Intel® Pentium® Processor N4200 and Celeron® Processors J3355, J3455 & N3350 for Internet of Things Platforms

Specification Update Addendum - Public

Revision 002

Document Number: 615560

6.1.4.2 Package Diagrams

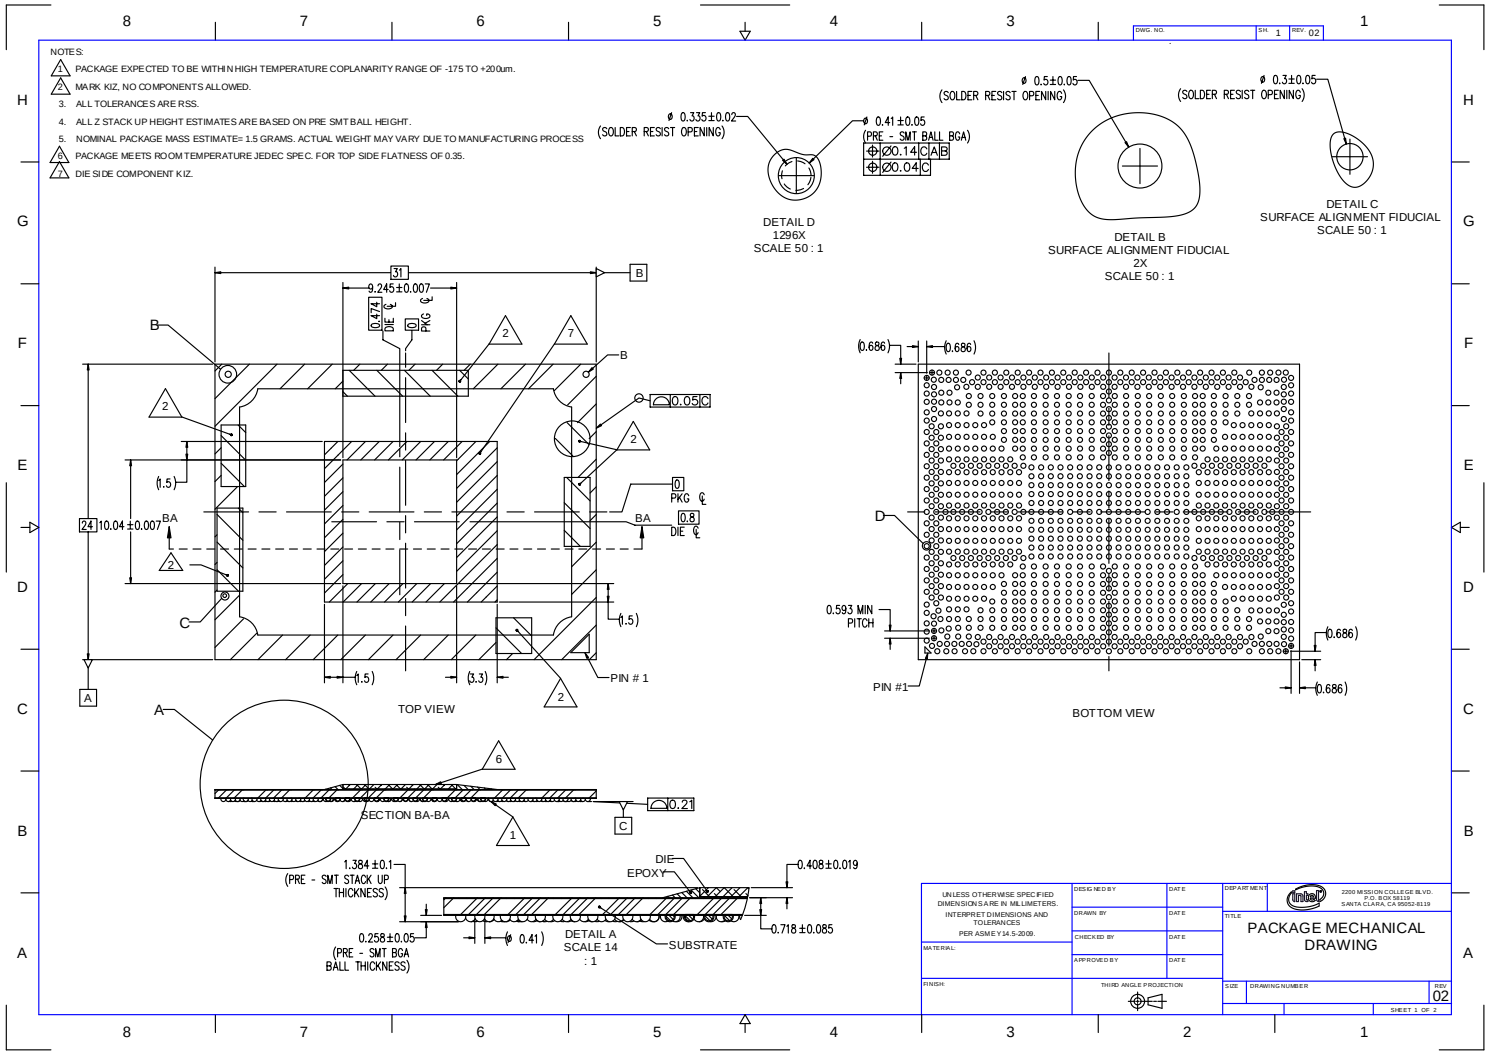
For the Intel® Pentium® processor N4200 and Intel® Celeron® processors J3355, J3455 & N3350, Figure 7-1 in EDS Volume 1 (Document number: 334817) is updated as described below:
